**Marathon
Petroleum Company LP**

**RE: Response to Approval with Modifications
2017 Annual Groundwater Report
OW-61 Through OW-65 Well Installation Report
Marathon Petroleum Company LP, Gallup Refinery
(dba Western Refining Southwest, Inc.)
EPA ID# NMD000333211
HWB-WRG-18-014**

RESPONSE TO COMMENTS
August 23, 2019 Approval with Modifications, Response to Disapproval Annual Groundwater
Monitoring Report Gallup Refinery - 2017
(June 2019)

FIGURE 3
CROSS SECTION A - A'
LOCATION MAP

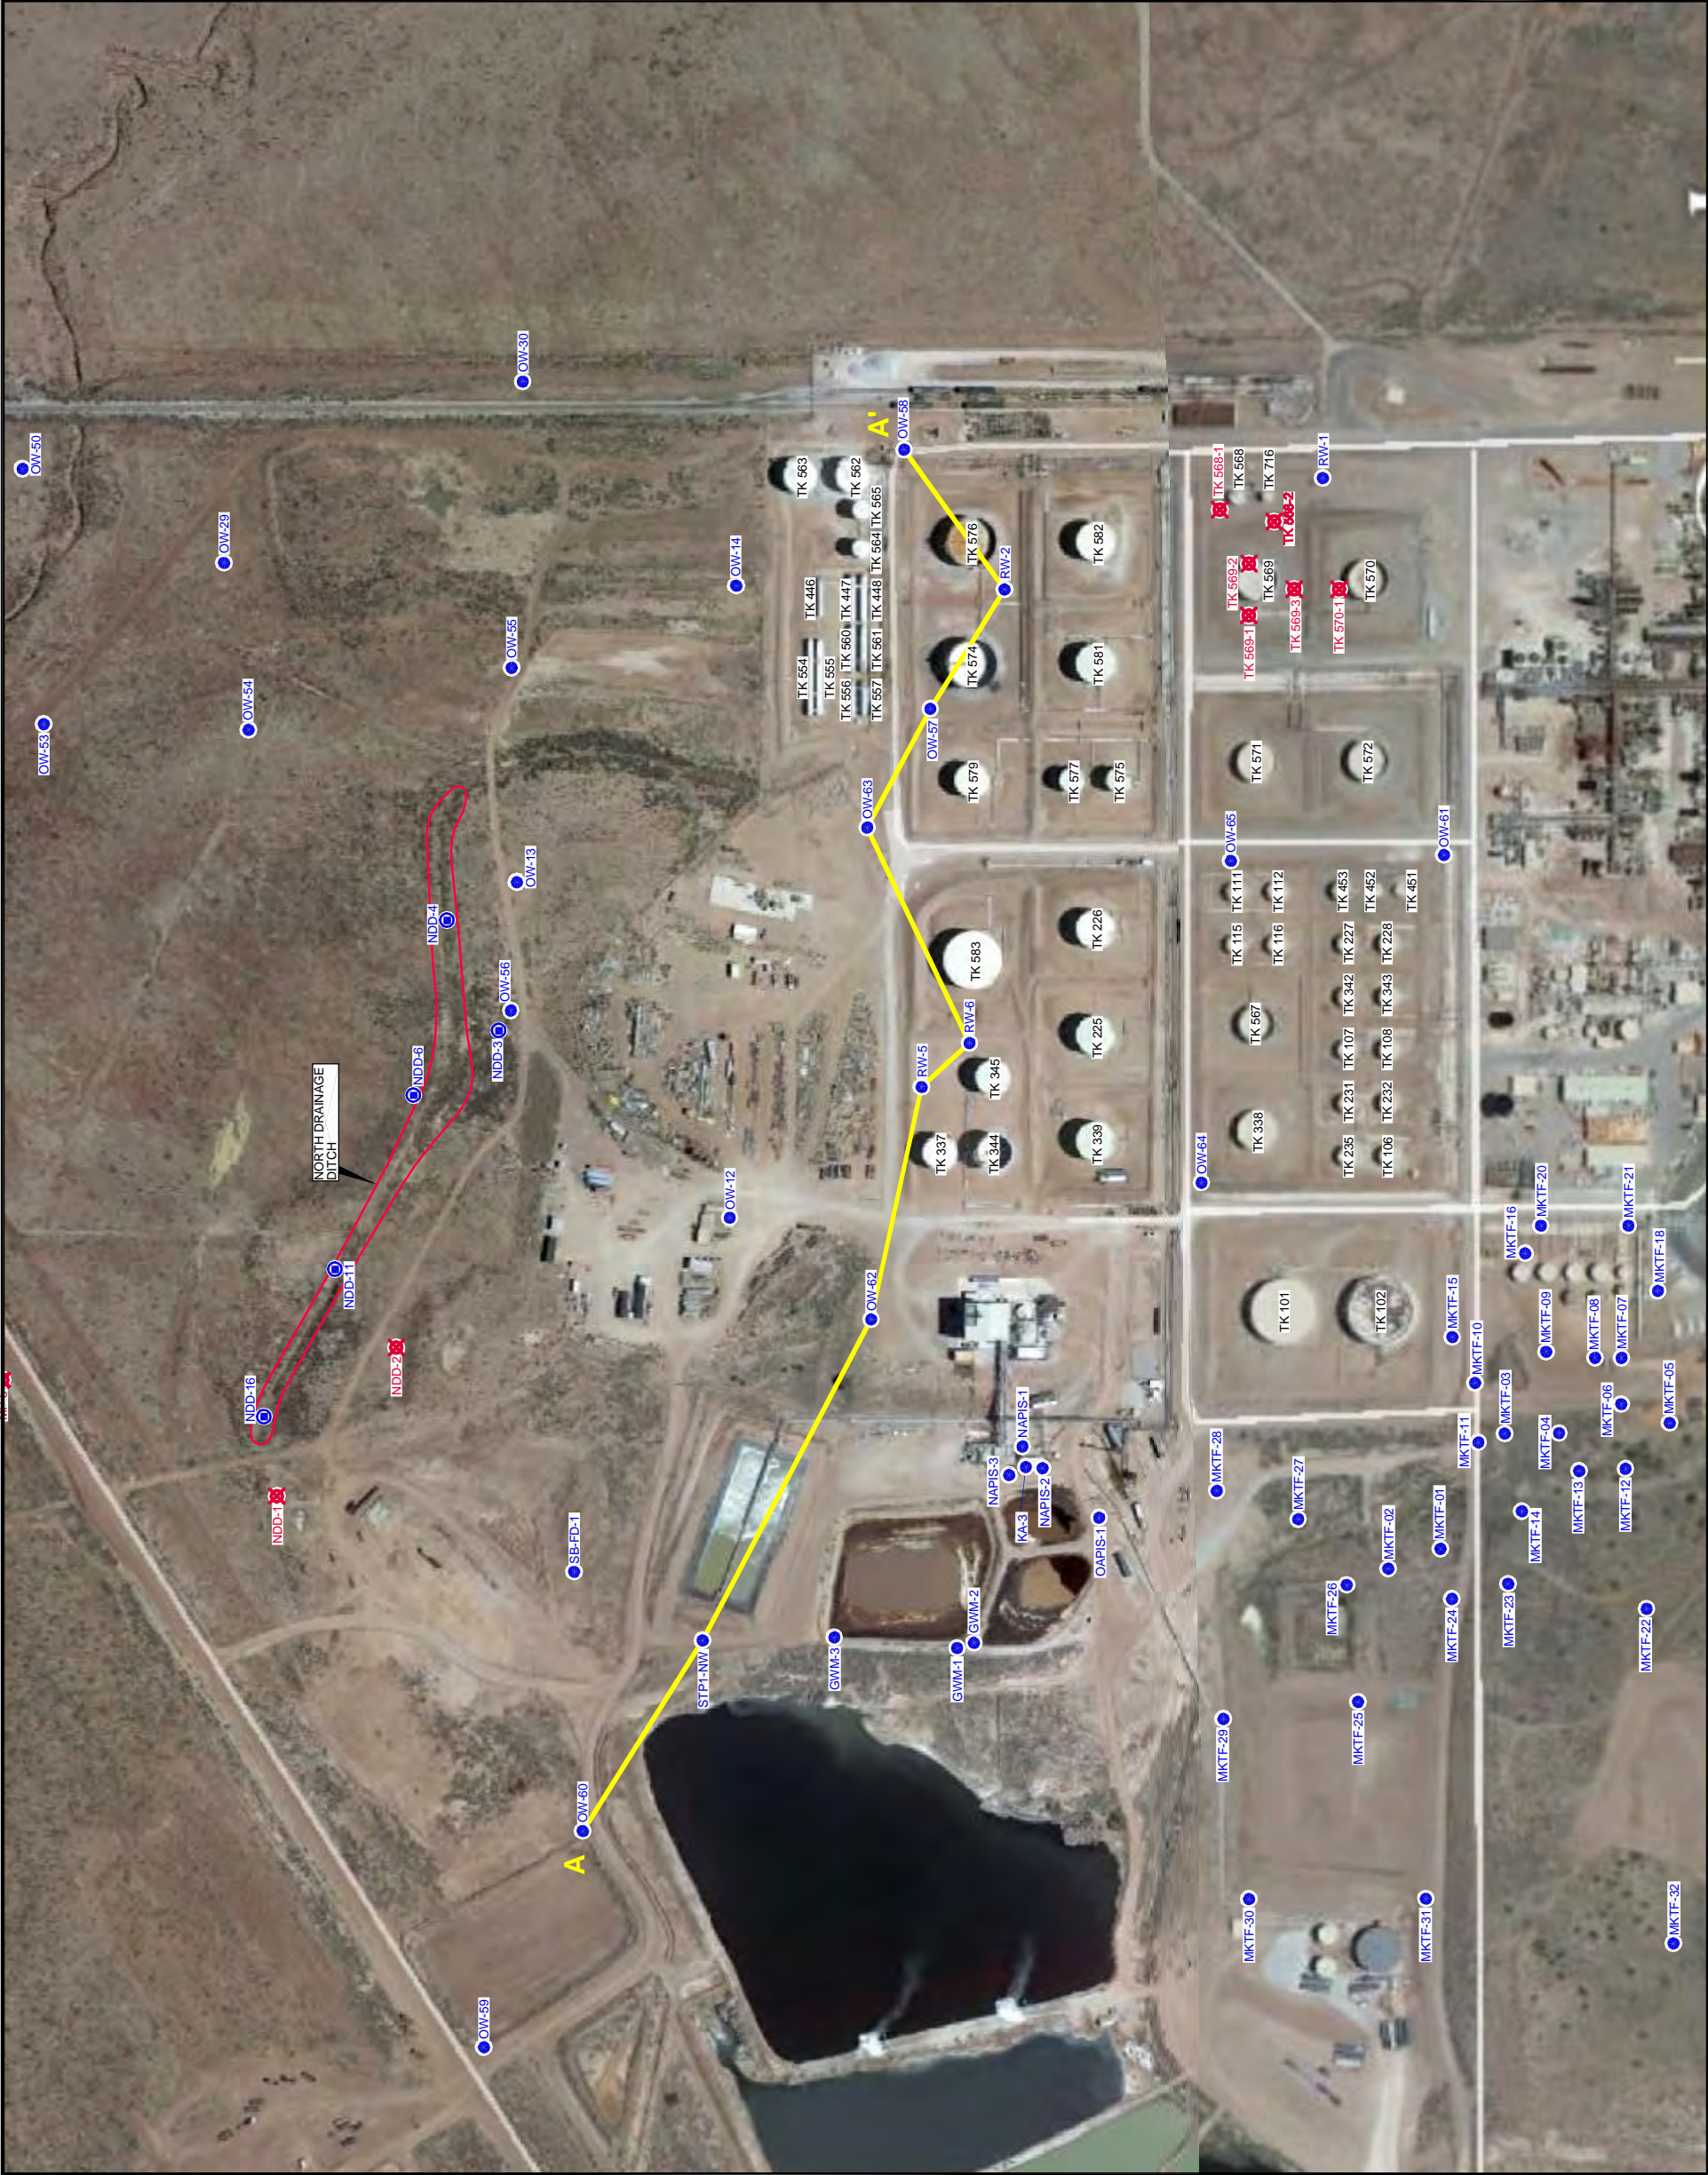
Figure 3 shows the location of a cross-section that runs along the northern portion of the tank farm and extends west to near STP-1. The cross-section included as Figure 4, incorporates OW-62 and OW-63.

WELL LOCATION MAP

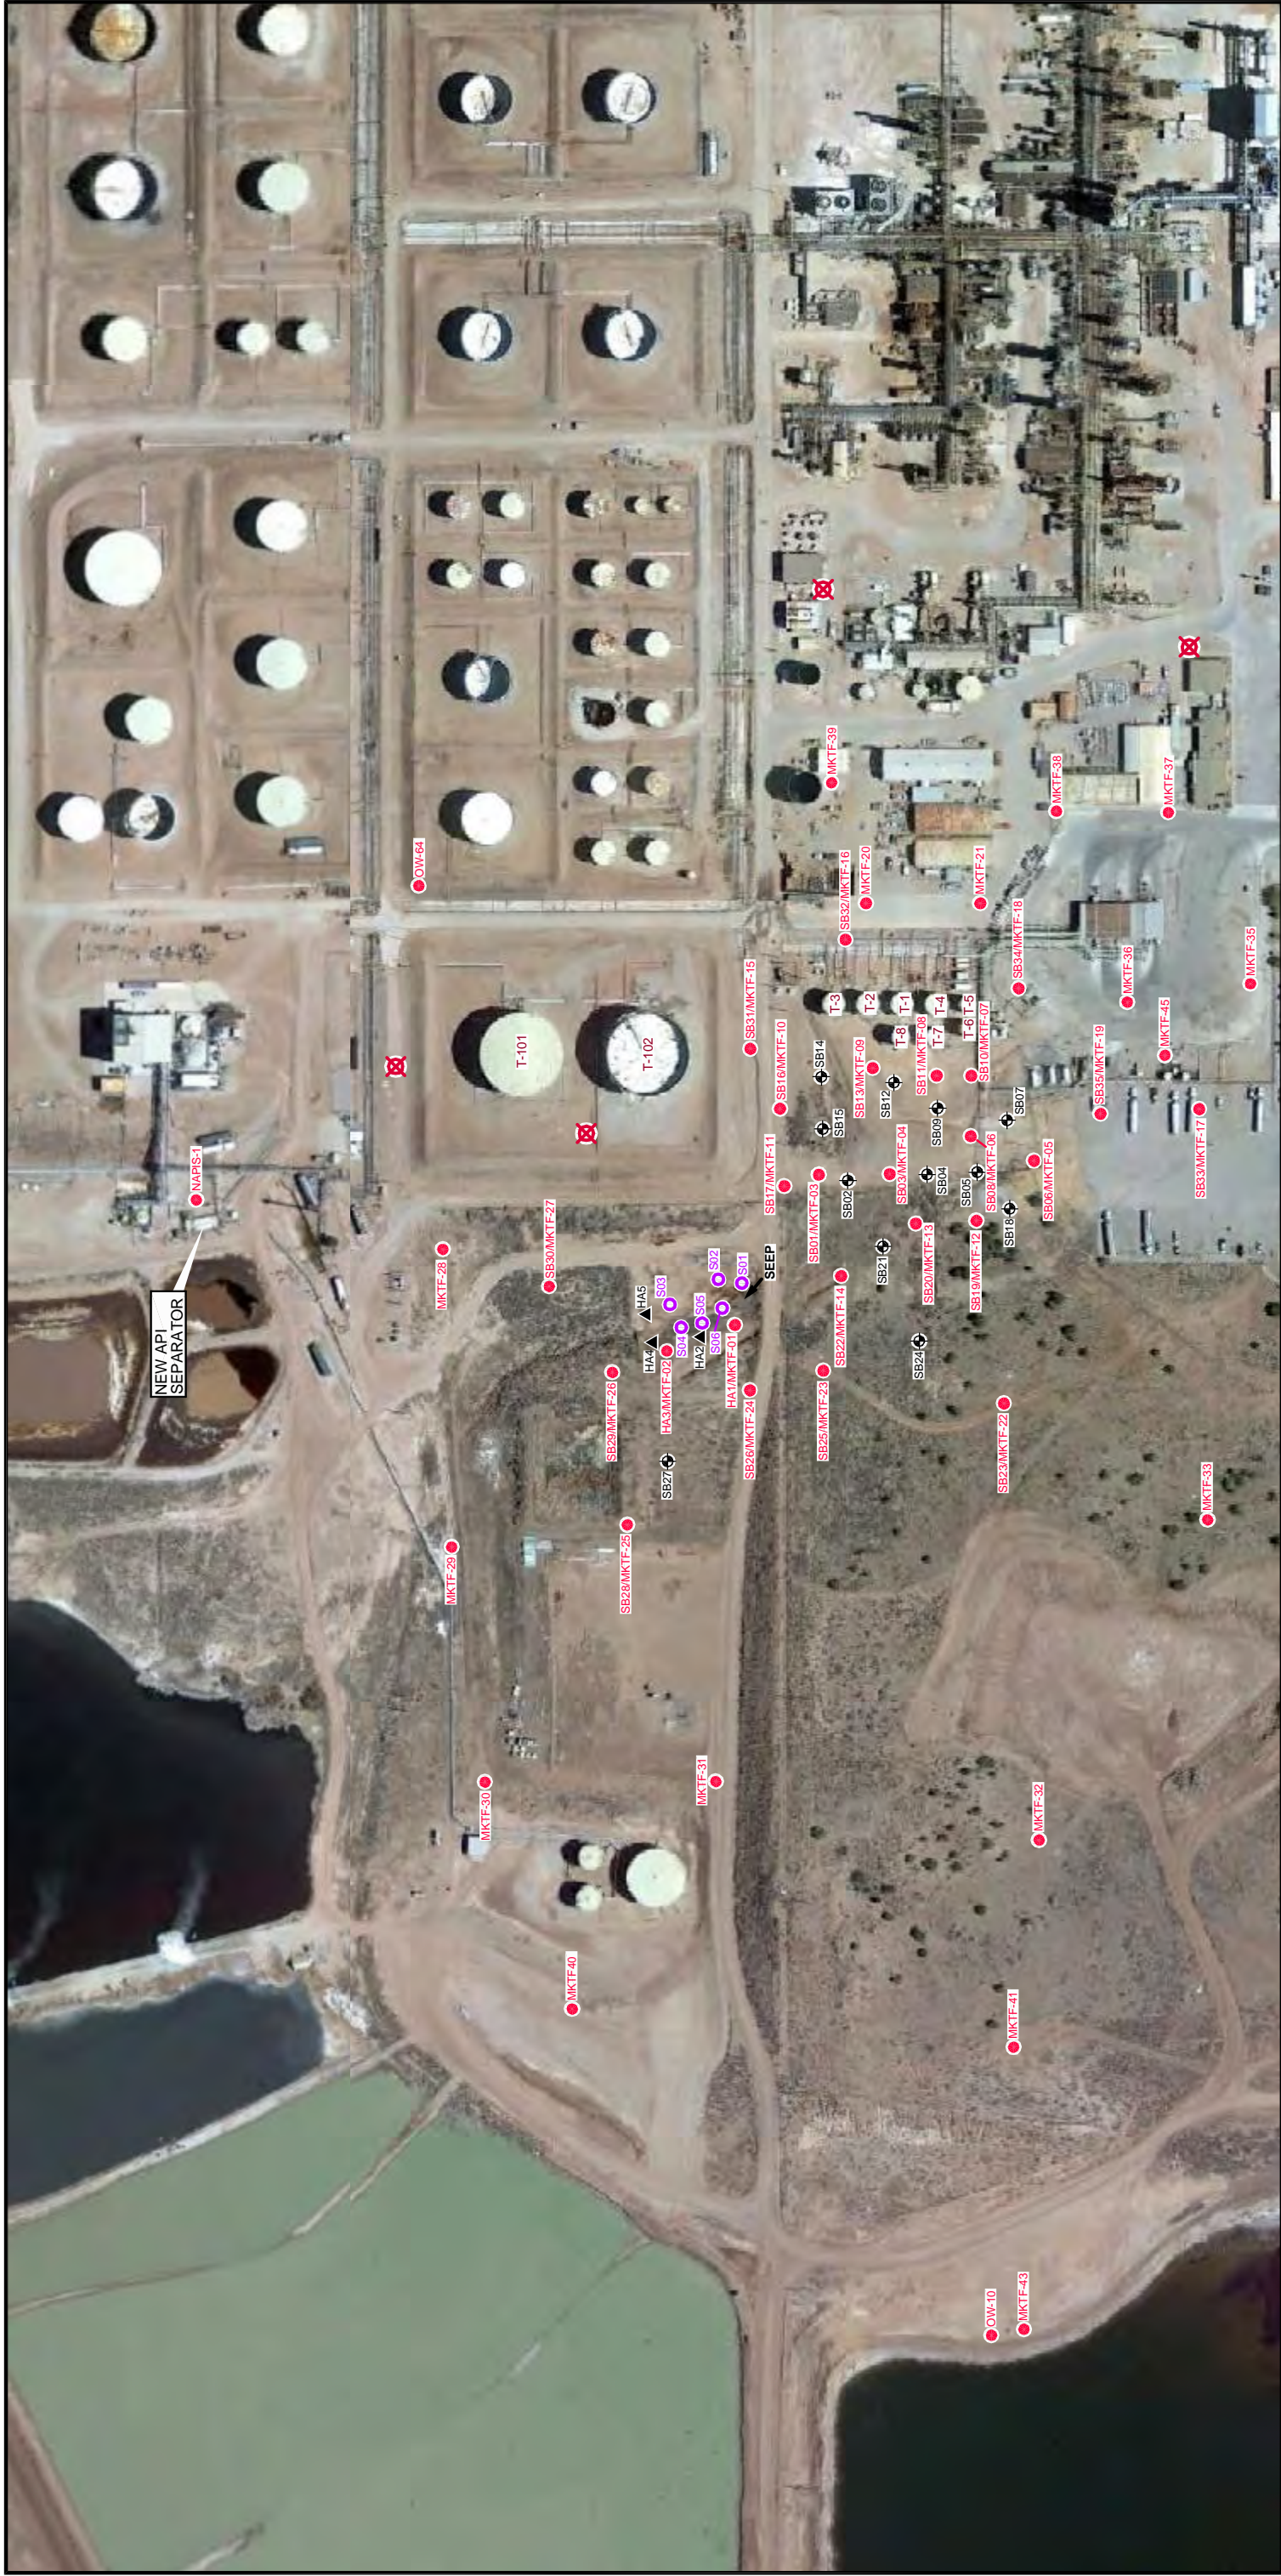
Figure 6 (Facilities and Well Groups – 2017) does not show the location of wells OW-61 through OW-65, as these wells did not exist in 2017. Wells OW-61 through OW-65 were installed in 2018 and a separate Well Installation Report has been prepared as requested. The requested figure is included in the Well Installation Report, which is enclosed.

The locations of the new observation wells (OW-61, OW-62, OW-63, OW-64, and OW-65) are shown on Figure 2. These wells were installed on a voluntary basis without prior approval of a specific Work Plan in order to determine the possible presence of separate-phase hydrocarbon (SPH) in the vicinity of the tank farm after SPH was found in the discharge from the French drain located near STP-1. The occurrence of SPH was identified on February 6, 2018. The associated Form C-141 is provide in Appendix D. The wells were installed in March 2018.
